Staff Report - Certificate of Appropriateness Application

Knoxville Historic Zoning Commission

File Number: 12-F-19-HZ

PROPERTY LOCATION: 1610 Forest Ave. / Parcel ID 94 N E 015

Front Elevation

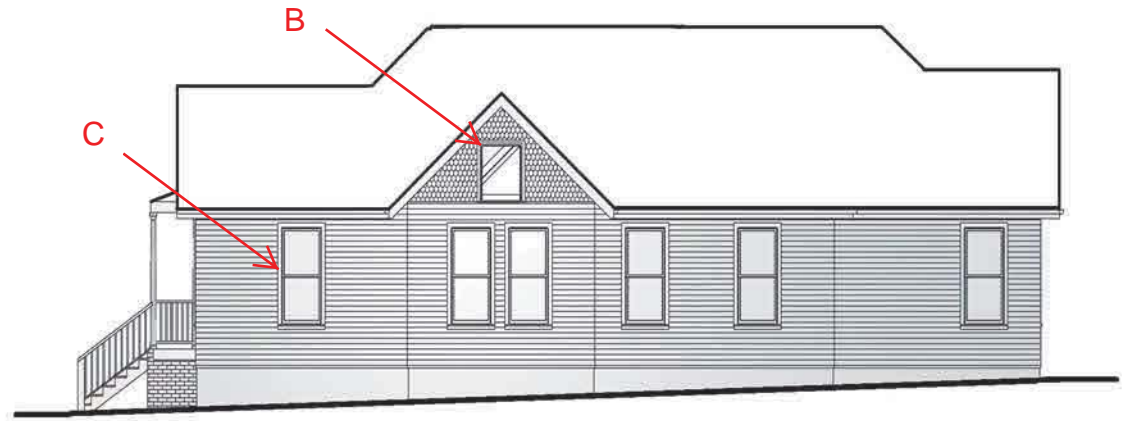
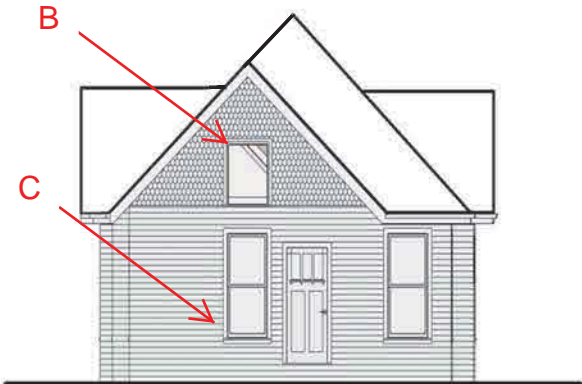
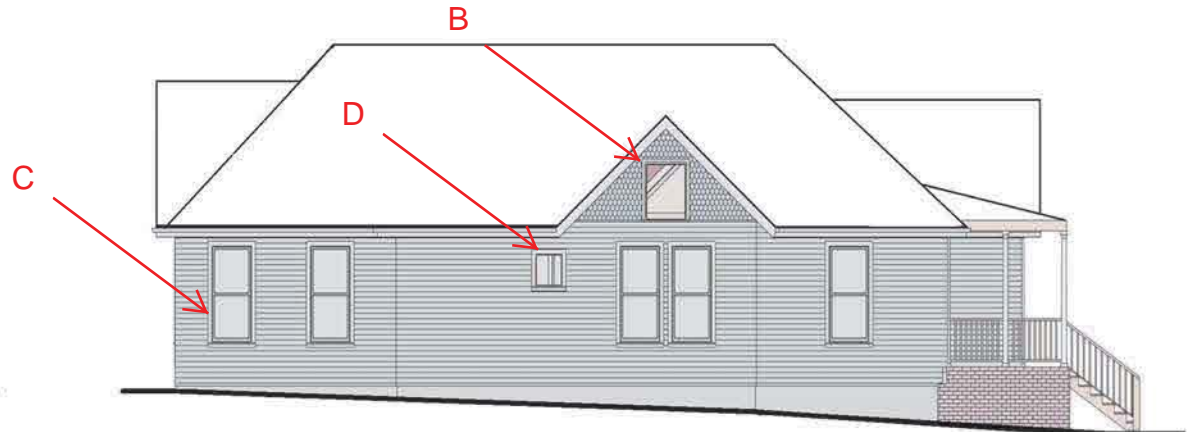
of the neighborhood. Based on recommendations in the December 2019 staff report, applicant has added one additional window on the rear section of the east elevation to provide additional transparency and better reflect historic proportions.

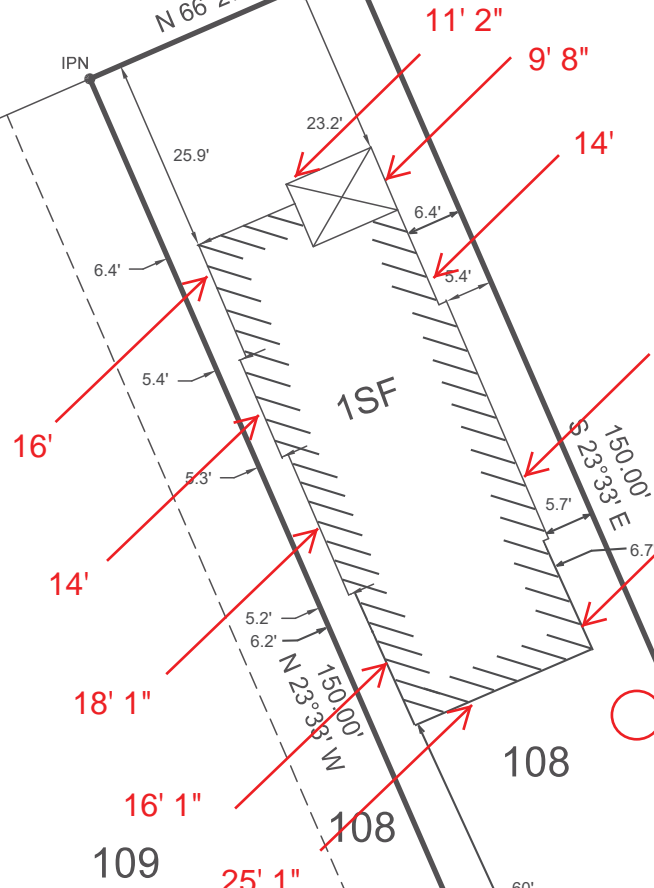
New Shade tree as recommended

Staff recommends approval of the work as proposed, with the conditions that 1) one native shade tree be planted in the rear yard and 2) parking to meet requirements delineated in the City zoning ordinance.

MAIN LEVEL

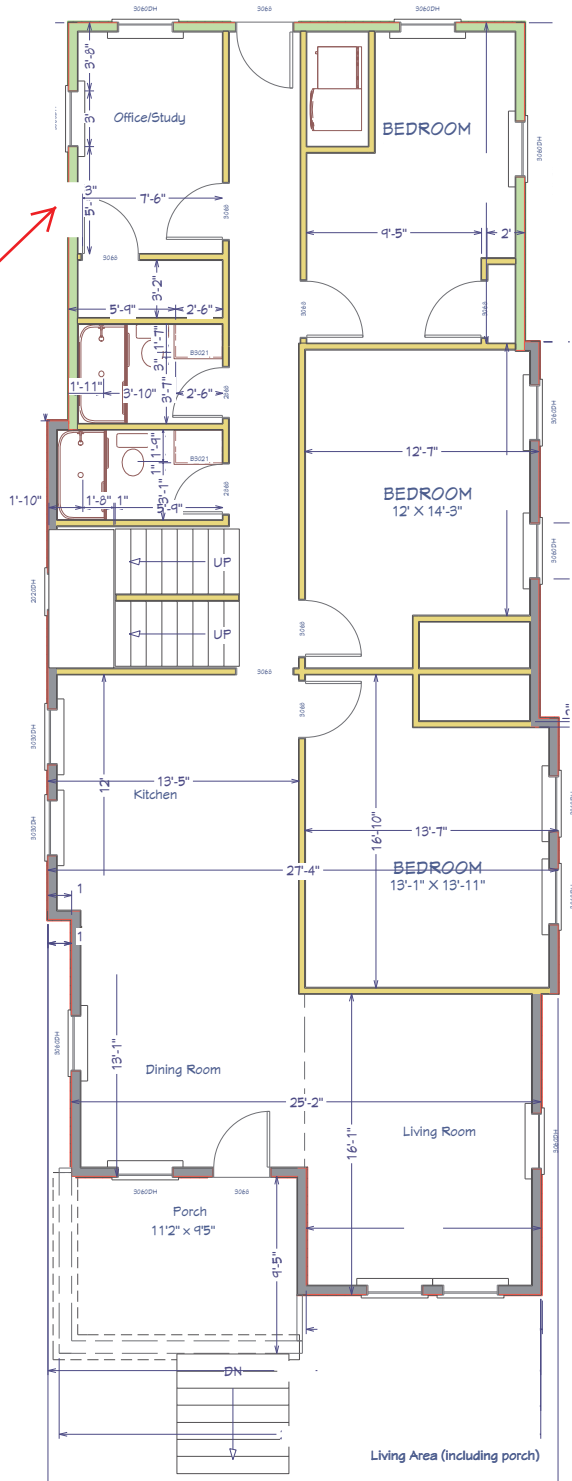
Additional window added as recommended at December 2019 meeting
